SUBJECT: ISSUANCE OF AMENDMENT NO. 128 TO FACILITY OPERATING LICENSE NO.
DPR-23 REGARDING POWER DISTRIBUTION CONTROL - H. B. ROBINSON
STEAM ELECTRIC PLANT, UNIT NO. 2 (TAC NO. 74838)

AMENDMENT NO. 128 TO FACILITY OPERATING LICENSE NO. DPR-23 - ROBINSON,
UNIT NO. 2

SAFETY EVALUATION BY THE OFFICE OF NUCLEAR REACTOR REGULATION
RELATED TO AMENDMENT NO. 128 TO FACILITY OPERATING LICENSE NO. DPR-23
CAROLINA POWER & LIGHT COMPANY
H. B. ROBINSON STEAM ELECTRIC PLANT, UNIT NO. 2
DOCKET NO. 50-261

Figure 3.10-4

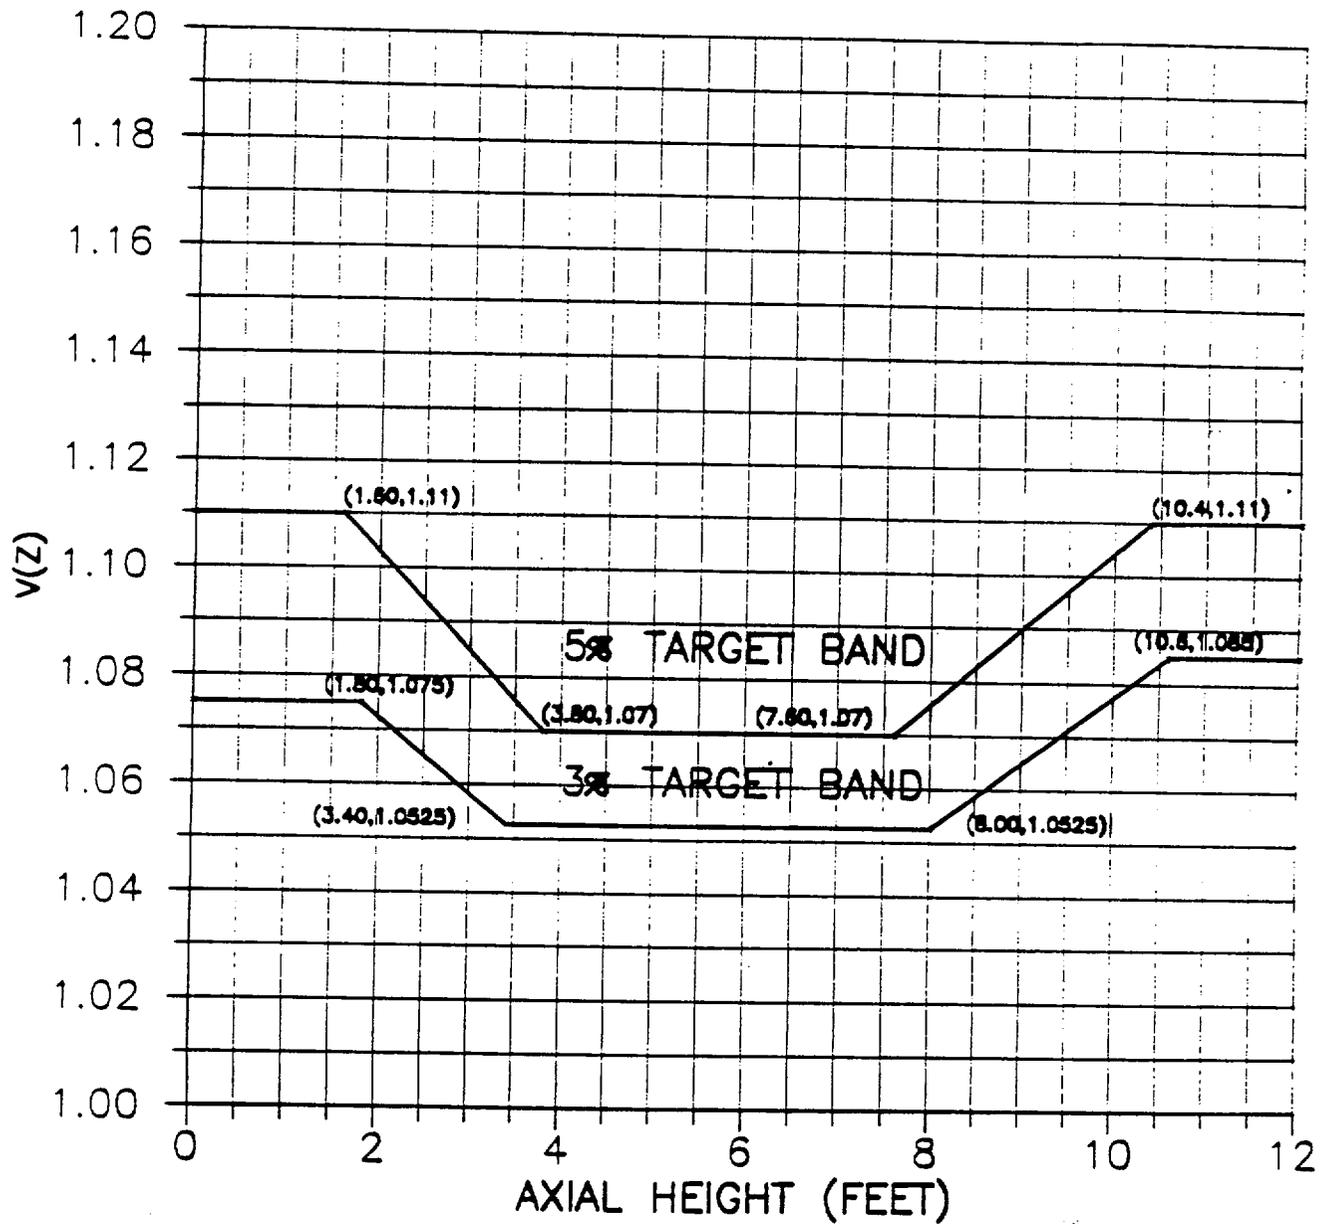
The amendment changes TS Figures 3.10-4 and 3.10-5. These changes incorporate the results of analyses using a new three dimensional analytical technique that more explicitly models the plant-specific core power distributions.

The TS changes result from changes to the ANF analysis methodology, i.e., a change from PDC-2 to PDC-3. The PDC-3 methodology for calculating $V(Z)$ retains previous general characteristics, but has been changed in several details. The primary differences are:

- (1) The core average radial and axial behavior analysis in steady state and power maneuvers is done with three-dimensional (3D) XTG (Reference 2), rather than using the PDC-2 methodology of one dimensional (1D) XTG and conservative radial peaking factors (F_{XY}).
- (2) An expanded set (relative to PDC-2) of power maneuver transients has been used in the analyses to provide a more conservative set of transient values for $F_Q(Z)$ and the development of $V(Z)$.

The full 3D XTG and expanded operating modes PDC-3 methodology has been applied to HBR2. For this analysis an HBR2 specific model was developed rather than using a generic model as had previously been done with the PDC-2 methodology for HBR2 TS development. The parameters of cycle 12 were used in the model. The results of the calculations are new values for $V(Z)$ and for the limits for allowed operation outside of designated offset bands. These form the basis for the proposed changes to the current TS Figures 3.10-4 and 3.10-5. The changes are only to the calculation methodology. Operating procedures and other aspects of the power distribution TS are unchanged. The HBR2 cycle 12 characteristics differ from the generic PDC-3 "sample" plant in having: (1) a lower power density, (2) lower control bank (D) reactivity worth, and (3) natural uranium axial blankets. In keeping with the current TS, analyses were done for offset bands of both (plus and minus) 3 and 5 percent. The effect of control rod worth was examined by calculating $V(Z)$ for normal, plus and minus 15 percent and plus 30 percent Bank D reactivity worths. A composite $V(Z)$ was produced from the maxima of these results as a function of Z . A bounding, limiting $V(Z)$ was drawn above the composite curve which becomes the proposed TS curve of Figure 3.10-4.

Figure 3.10-5

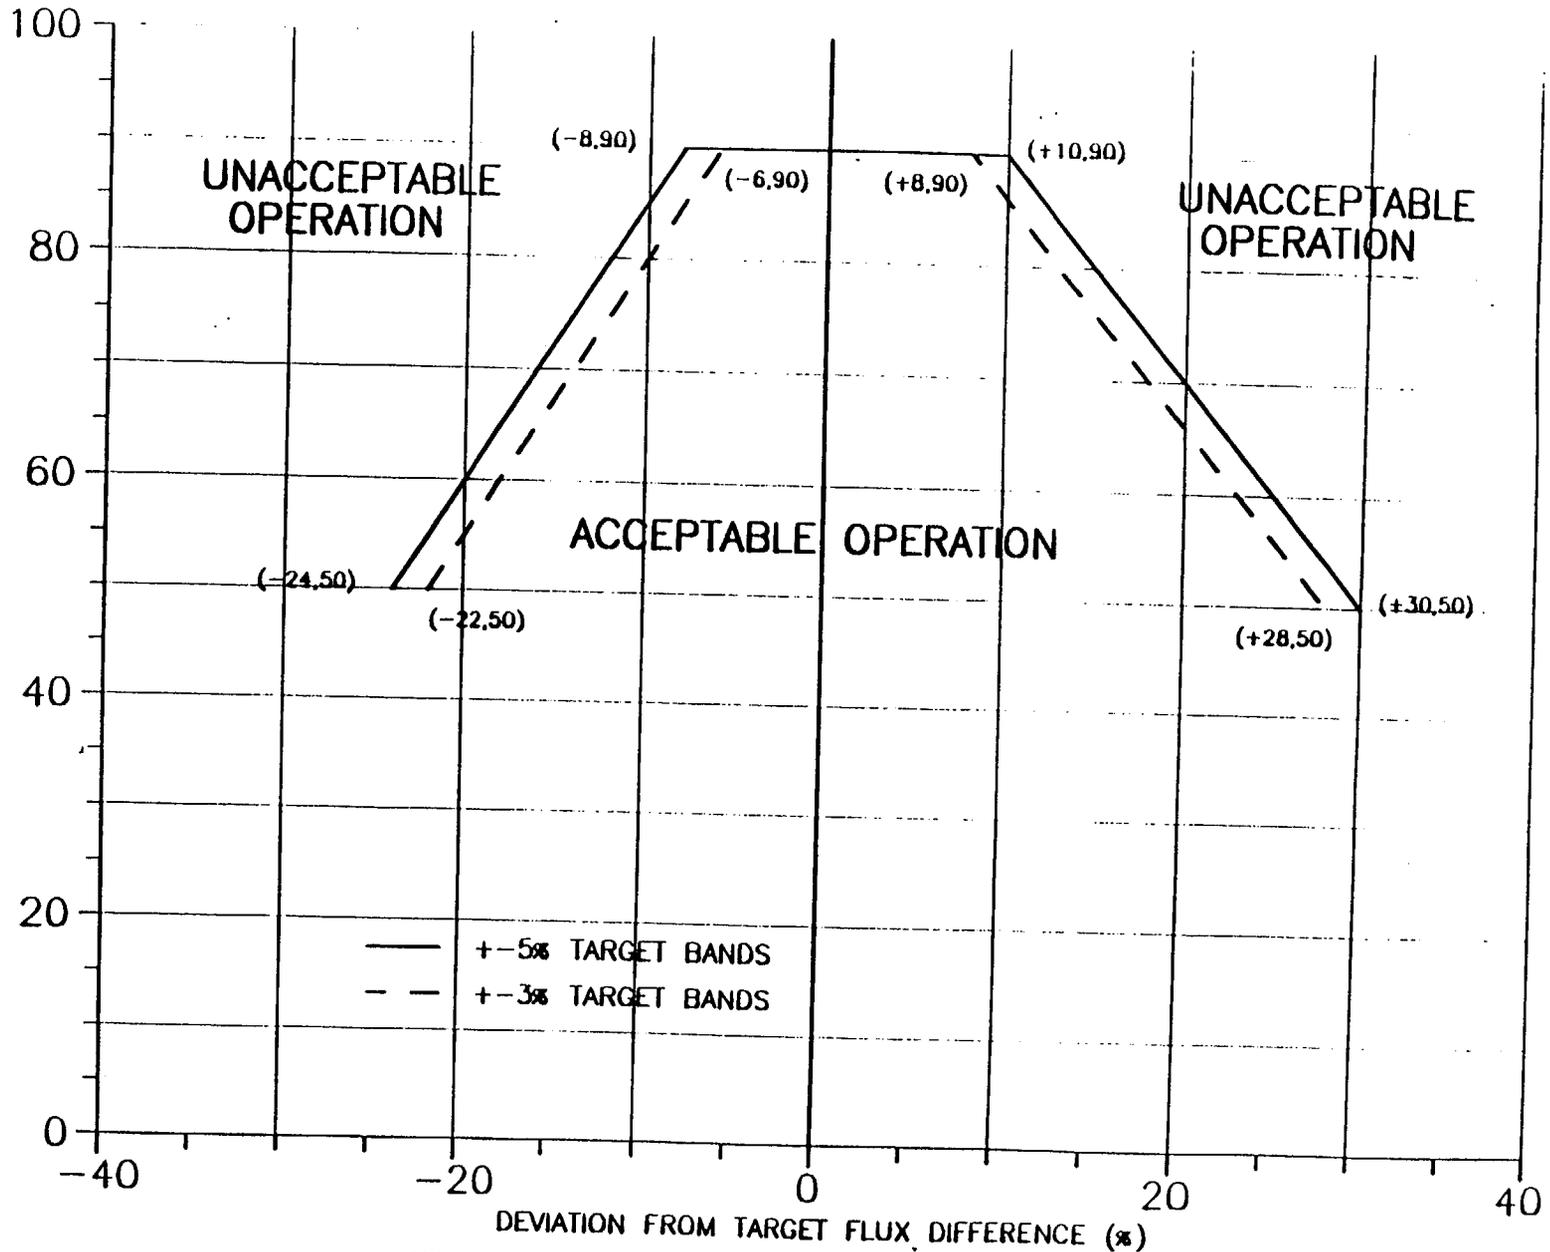
In the currently approved ANF power distribution operational methodology, during operation below 90 percent power, deviation of limited amounts outside of the allowed offset band is permitted for limited times. The offset limits are given in Figure 3.10-4. These limits have been reexamined using the HBR2 Cycle 12 model. Calculations were done for operations at various powers outside the band beginning from various extremes within the band. Allowed deviations were determined for both 3 and 5 percent band operation at powers from 90 to 50 percent. These differ slightly from current limits. The review has concluded that appropriate calculations have been done, the results are reasonable and both proposed TS changes are acceptable.
